SDC Design Update

816 Mercer

April 15, 2021

Previously Presented Design SDC Comments

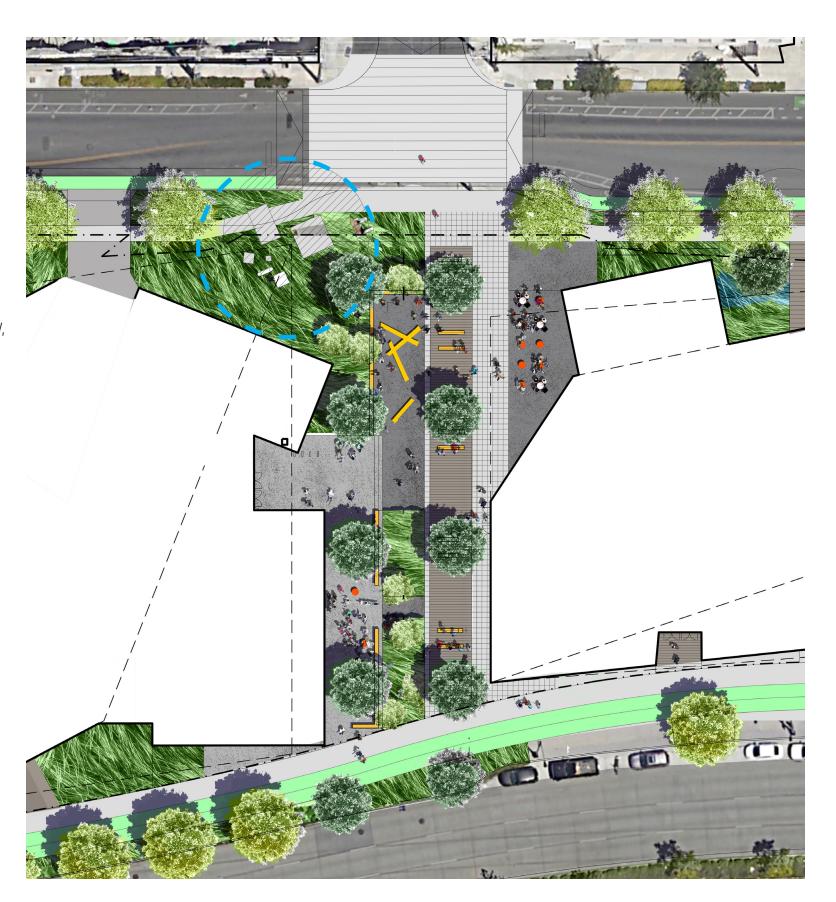
- 1 Provide information on how sustainability is being integrated into the design concept.
- Provide information on programming, specifically how the design will function for public gatherings, festivals, etc, as well as how the building and public easement will relate with the immediate surroundings.

- 3 Evaluate the use of materials in the 8th Ave public easment and Community Center to ensure that the spaces feel like they are publicly accessible.
- Evaluate how the 8th Ave public easement design relates to other adjacent City streets and public ROW, including how standard ROW improvements will be incorporated through the site balanced against custom or unique elements.

- Integrate lighting and seating in a way that will feel public.
- 6 Design north entry to serve as gateway for pedestrians accessing the site.
- 7 Be creative about design around King County utilities. Consider incorporation of artistic elements and access to make it feel welcoming.

- Reconsider the function of a raised intersection at the intersection of 8th Ave N and Roy St to see if funding could be better used elsewhere.
- 9 Evaluate location of spaces and their role in circulation/connectivity and gathering spaces. Determine location of trees and other vegetation will reduce impacts of mobility and circulation through the site.

- Look to ways to expand the public nature of the space including the use of site furniture that can be used by the community to elevate public nature of the space and its relationship to the surrounding neighborhoods.

Healthier Ground

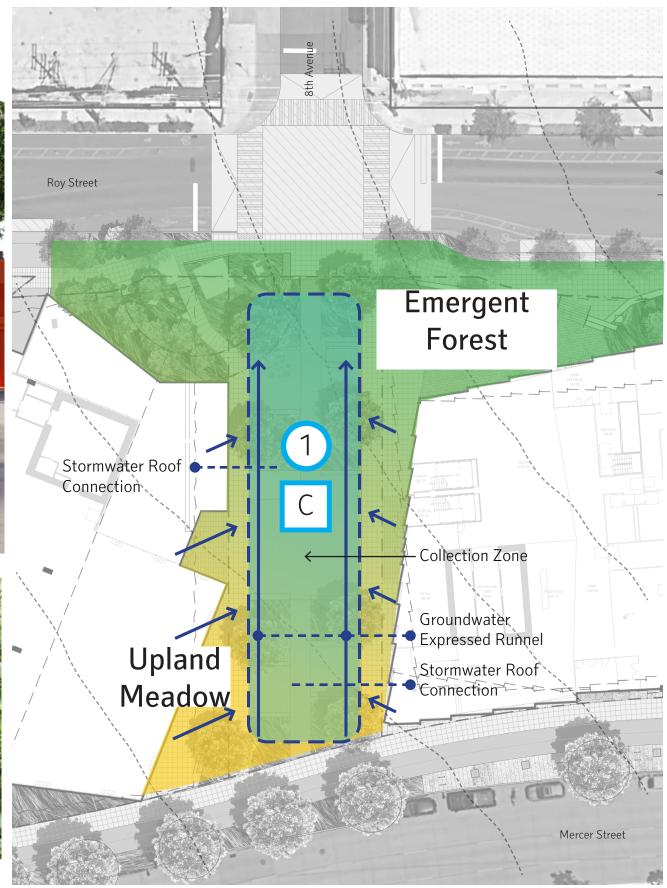
1 SDC Comment: Sustainability integration

C SDCI LD C: Expressive stormwater management

Building on the typical street and guidelines for 8th Avenue, the project maintains the clear structure of paths of travel and trees while expanding the amenity zone given this is not a vehicular drive.

Shady Seasonally Wet Woodland

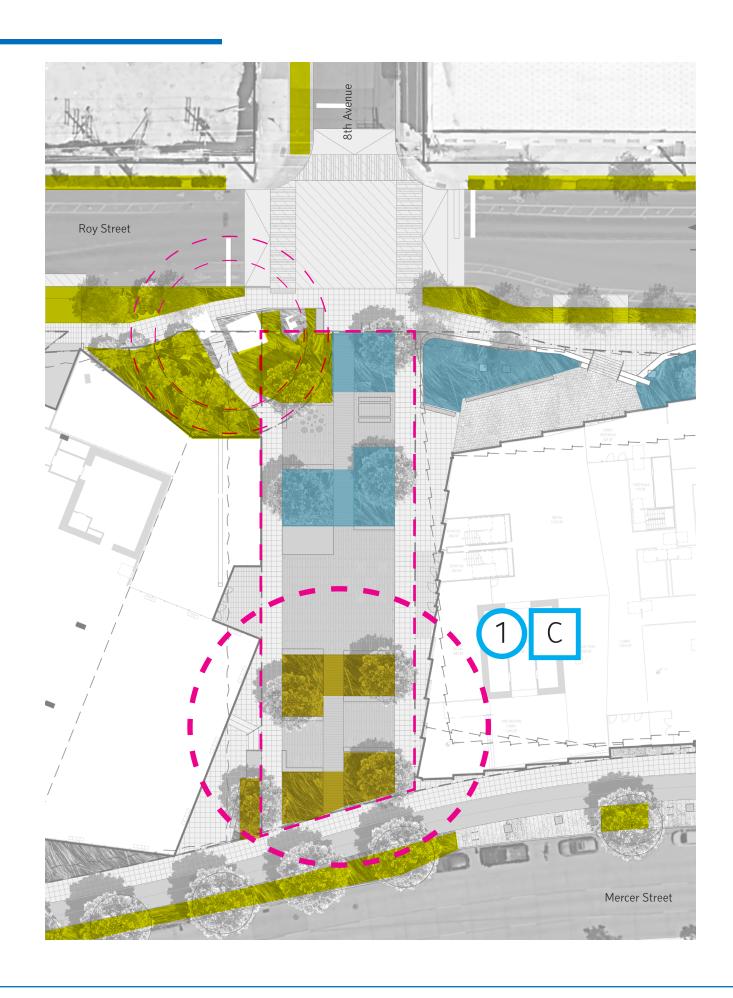
1 SDC Comment 1: Sustainability integration

C SDCI LD C: Expressive stormwater management

Trees

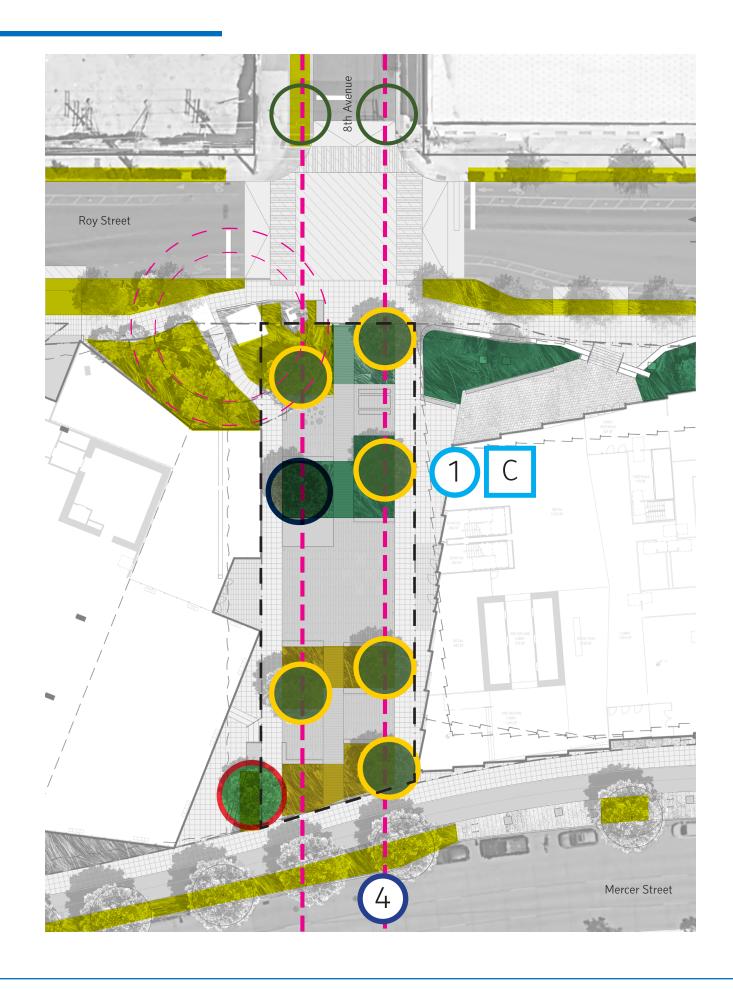
- 1 SDC Comment 1: Sustainability integration
- C SDCI LD C: Expressive stormwater management
- 4 SDC Comment 4: Evaluate how the 8th Ave public easement design relates to other adjacent City streets and ROW, including how standard ROW improvements will be incorporated through the site.

Public Streets Framework

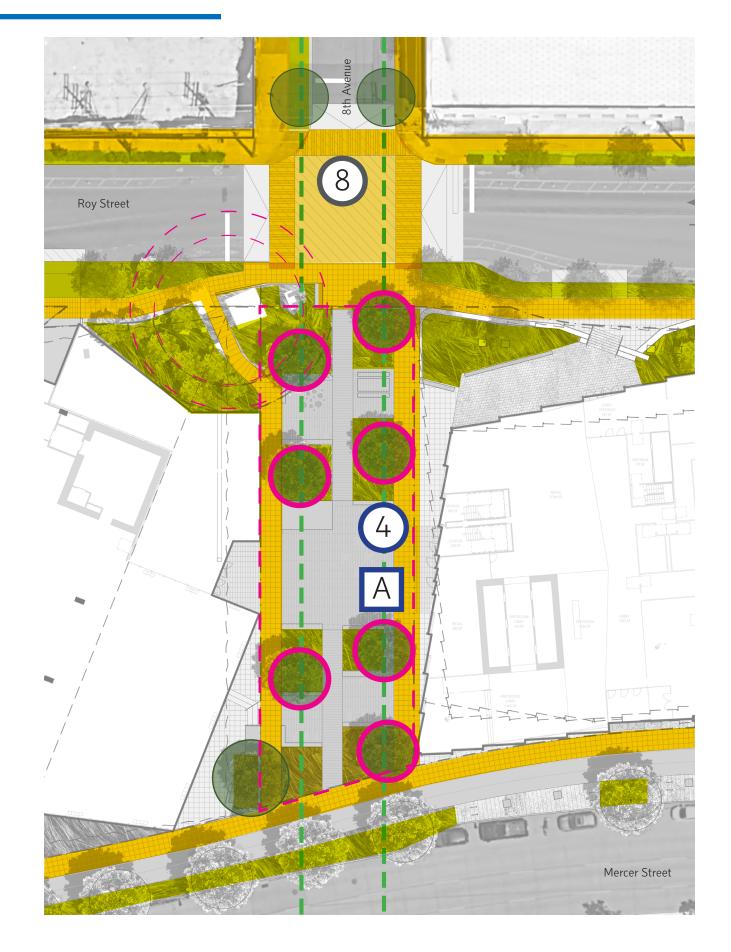
- 3) SDC Comment: Evaluate the use of materials in the 8th Ave easement to sure the space feels public.
- SDC Comment: Evaluate how the 8th Ave public easement design relates to other adjacent City streets and public ROW, including how standard ROW improvements will be incorporated through the site balanced against custom or unique elements.

- SDCI LD A: Staff recognizes the intent to connect this area with the larger street grid and convey its public nature through use of standard street features. However, as currently configured, it is difficult to see the connection. Please explore additional strategies for the deployment of these elements that will convey the intended message more effectively.

- **SDC Comment:** Reconsider the function of a raised intersection at the intersection of 8th Ave N and Roy St to see if funding could be better used elsewhere.

- **SDC Comment:** Evaluate location of spaces and their role in circulation/connectivity and gathering spaces. Determine location of trees and other vegetation will reduce impacts of mobility and circulation through the site.

- **SDC Comment:** Look to ways to expand the public nature of the space including the use of site furniture that can be used by the community to elevate public nature of the space and its relationship to the surrounding neighborhoods.

Materials

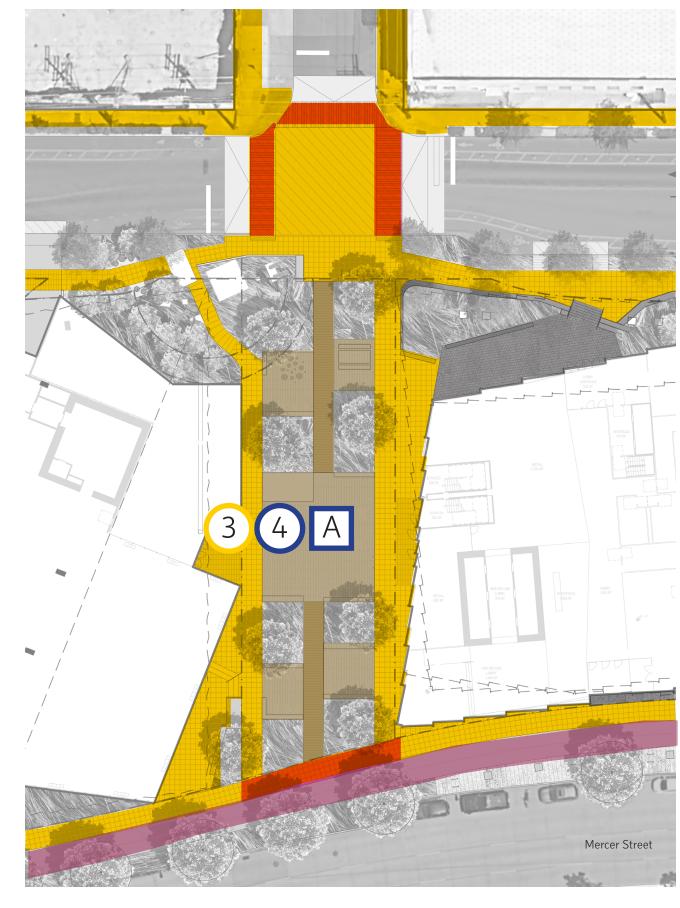
- 3 SDC Comment: Evaluate the use of materials in the 8th Ave public easement and community center to ensure that the spaces feel like they are publicly accessible.
- A SDC Comment 4/ SDCI LD A: Evaluate how the 8th Ave public easement design relates to other adjacent City streets and public ROW, including how standard ROW improvements will be incorporated through the site balanced against custom or unique elements.

Paver: Precast Plank Finish: Light Sandblast Dimension: 12"x84"

Paver: Concrete or stone paver
Finish: TBD
Dimension: TBD

Paving: 2'x2' Concrete Finish: Medium Sandblast

Asphalt Bike Path with contrasting curb for Ped safety.

Connectivity

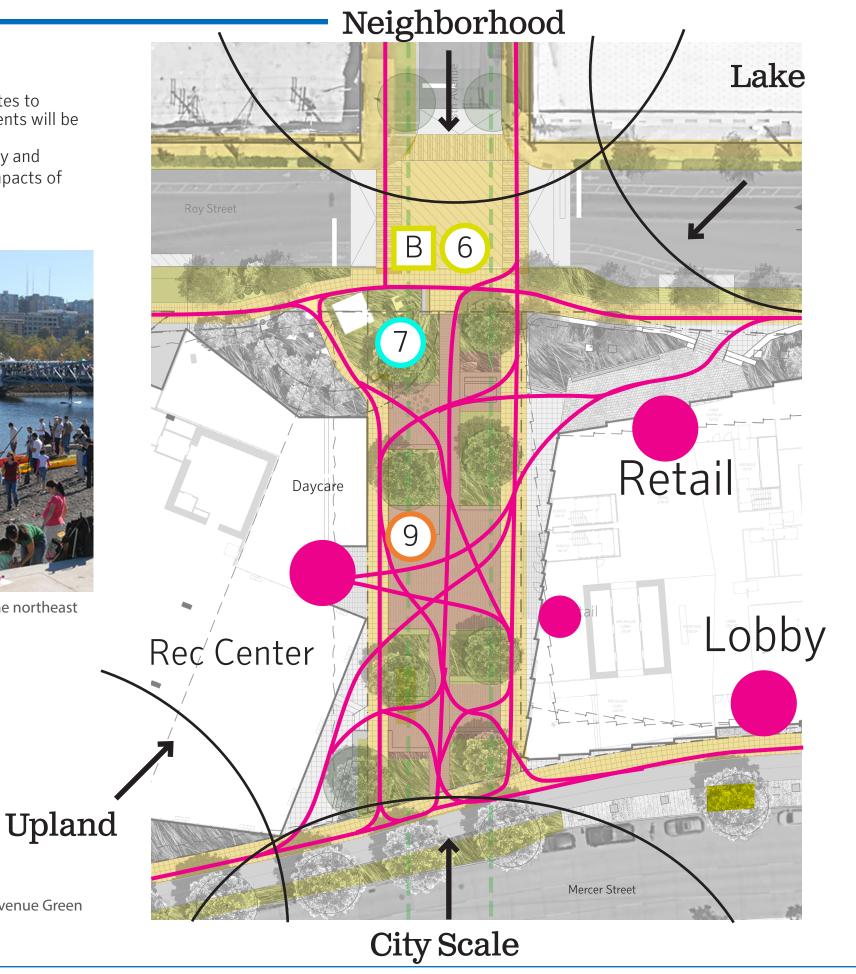
A SDC Comment 4/ SDCI LD A: Evaluate how the 8th Ave public easement design relates to other adjacent City streets and public ROW, including how standard ROW improvements will be incorporated through the site balanced against custom or unique elements.

SDC Comment 9: Evaluate location of spaces and their role in circulation/connectivity and gathering spaces. Determine how location of trees and over vegetation will reduce impacts of mobility and circulation through the site.

Lake Union Park sits only a block away to the northeast along Roy Street.

Denny Park to the south brackets the 8th Avenue Green street with a double block.

Public Rooms

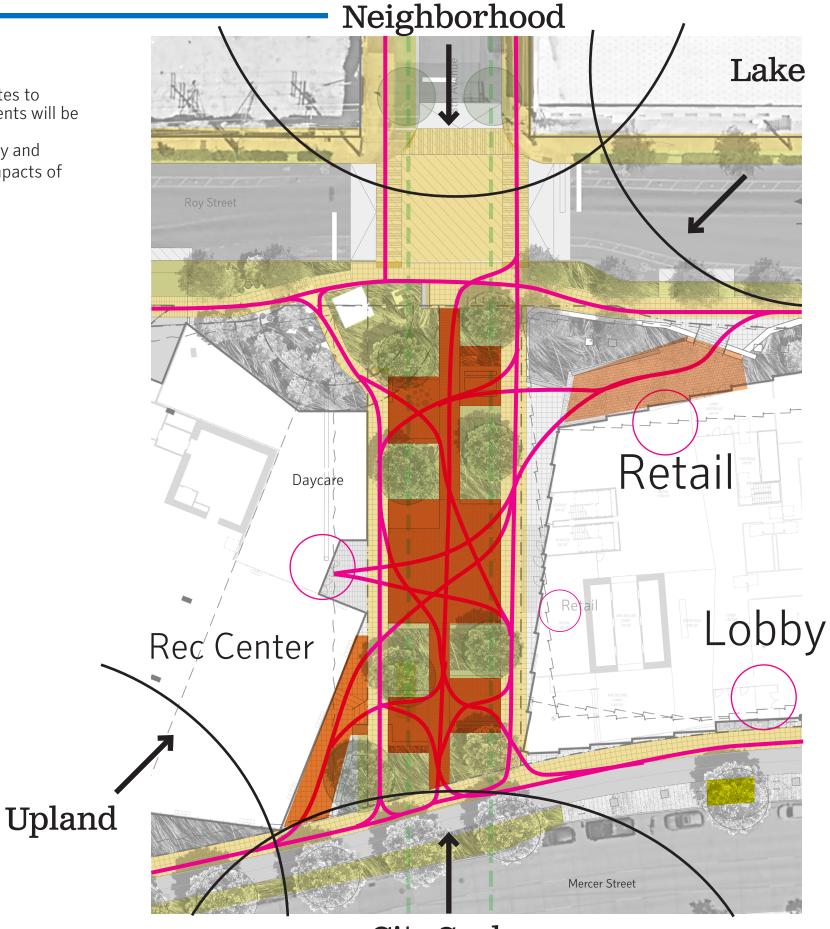
A SDC Comment 4/ SDCI LD A: Evaluate how the 8th Ave public easement design relates to other adjacent City streets and public ROW, including how standard ROW improvements will be incorporated through the site balanced against custom or unique elements.

SDC Comment 9: Evaluate location of spaces and their role in circulation/connectivity and gathering spaces. Determine how location of trees and over vegetation will reduce impacts of mobility and circulation through the site.

Rooms and Identities

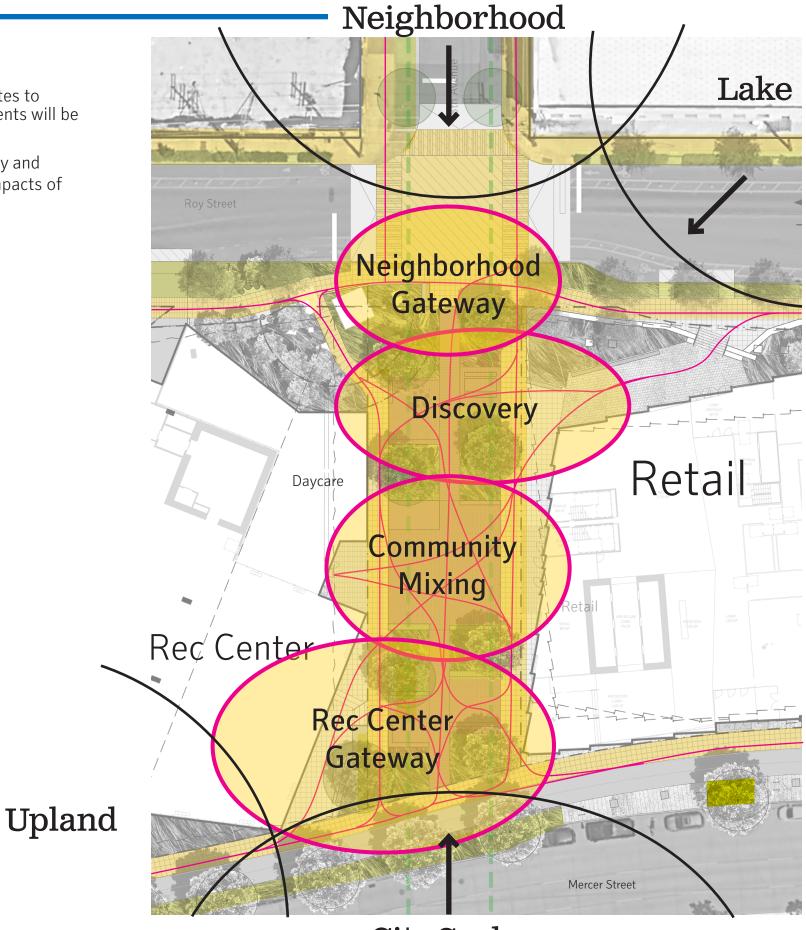
A SDC Comment 4/ SDCI LD A: Evaluate how the 8th Ave public easement design relates to other adjacent City streets and public ROW, including how standard ROW improvements will be incorporated through the site balanced against custom or unique elements.

9 SDC Comment 9: Evaluate location of spaces and their role in circulation/connectivity and gathering spaces. Determine how location of trees and over vegetation will reduce impacts of mobility and circulation through the site.

Three Zones

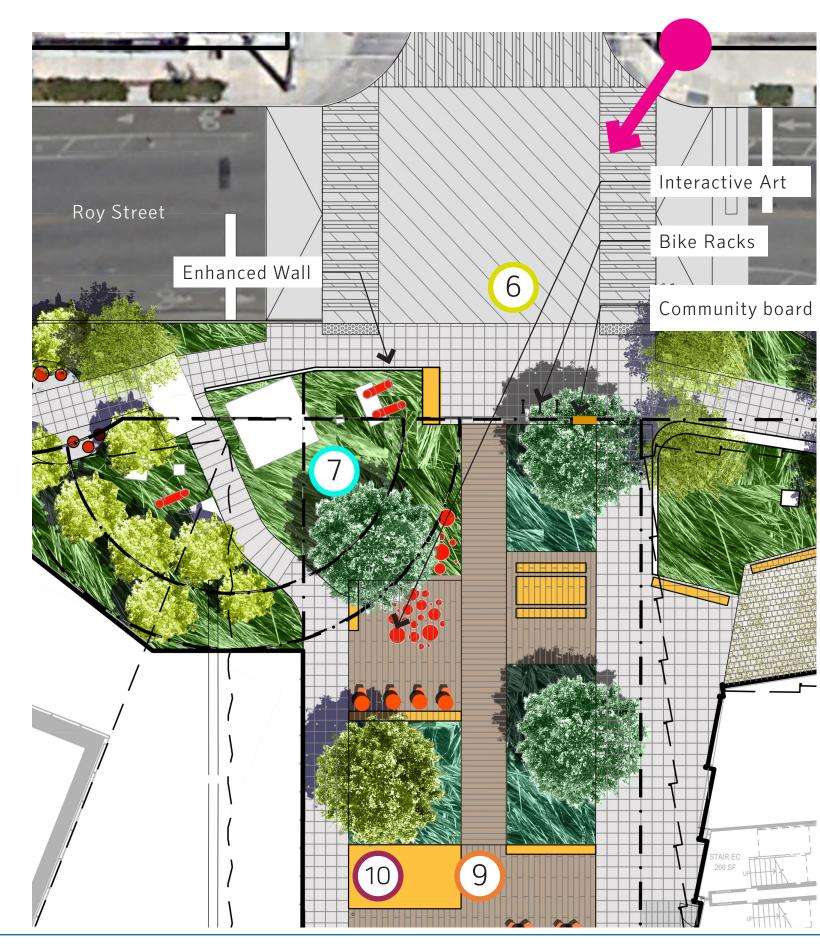
- SDC Comment: Programming for public gatherings, festivals, etc.

As well as how the building and public easement will relate with the immediate surroundings.
- A SDC Comment 4/ SDCI LD A: Evaluate how the 8th Ave public easement design relates to other adjacent City streets and public ROW, including how standard ROW improvements will be incorporated through the site balanced against custom or unique elements.
- SDC Comment: Integrate lighting and seating in a way that will feel public.

- Neighborhood invitation in
- Something inviting for kids

- Heart of the Cluster
- Highly traversed zone

- Transition between "big city" and 816 Mercer public realm
- Introduction to slow cut
- Foreground to Court Pavilion

Furnishings

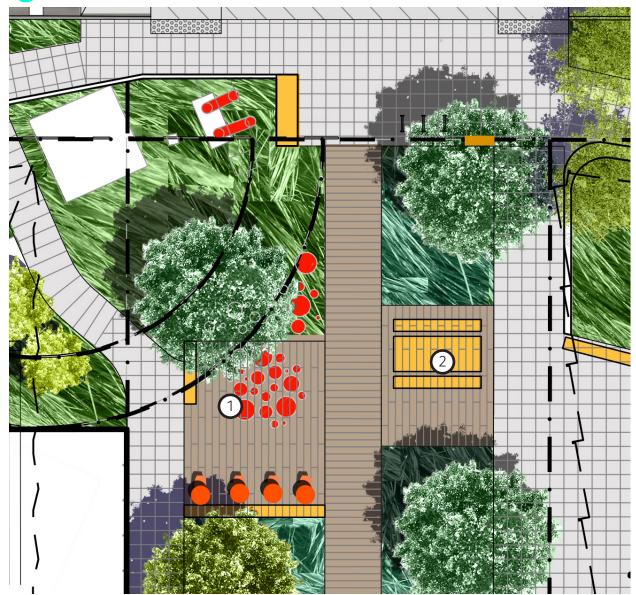
- 5 SDC Comment: Integrate lighting and seating in a way that will feel public.
- SDC Comment 10: Look to ways to expand the public nature of the space including the use of site furniture that can be used by the community to elevate public nature of the space and its relationship to the surrounding neighborhoods.

Community Discovery Room

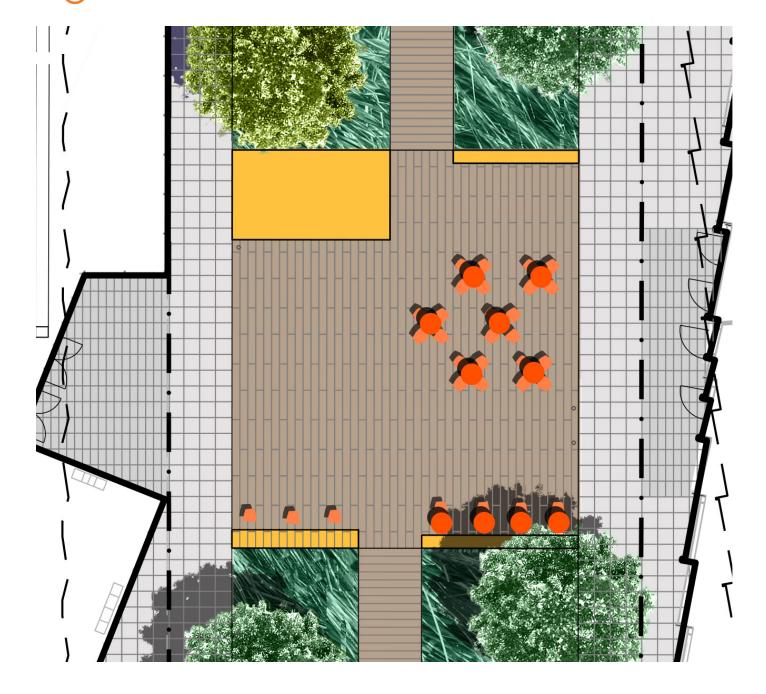
- 3SDC Comment: Evaluate the use of materials in the 8th Ave public easement and Community Center to ensure that the spaces feel they are publicly accessible.
- **SDC Comment**: Integrate lighting and seating in a way that will feel public
- 7 SDC Comment: Be creative about the design around King Country Utilitites consider art.

9 SDC Comment: Evaluate the location of spaces and their role in circulation/connectivity and gathering spaces.

Mixing Room

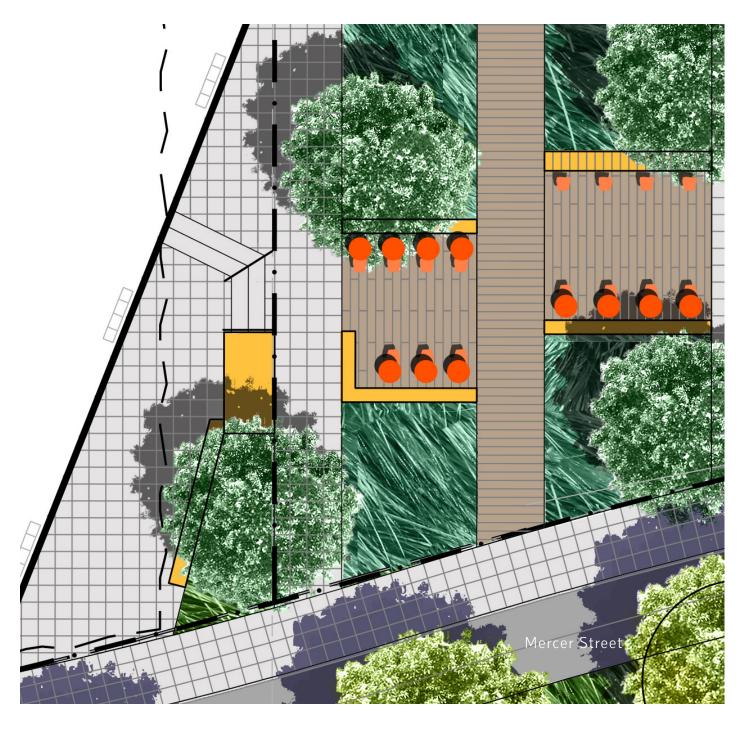
- 3SDC Comment: Evaluate the use of materials in the 8th Ave public easement and Community Center to ensure that the spaces feel they are publicly accessible.
- 5SDC Comment: Integrate lighting and seating in a way that will feel public
- (9) SDC Comment: Evaluate the location of spaces and their role in circulation/connectivity and gathering spaces.

- 3SDC Comment: Evaluate the use of materials in the 8th Ave public easement and Community Center to ensure that the spaces feel they are publicly accessible.
- 5SDC Comment: Integrate lighting and seating in a way that will feel public
- (9) SDC Comment: Evaluate the location of spaces and their role in circulation/connectivity and gathering spaces.
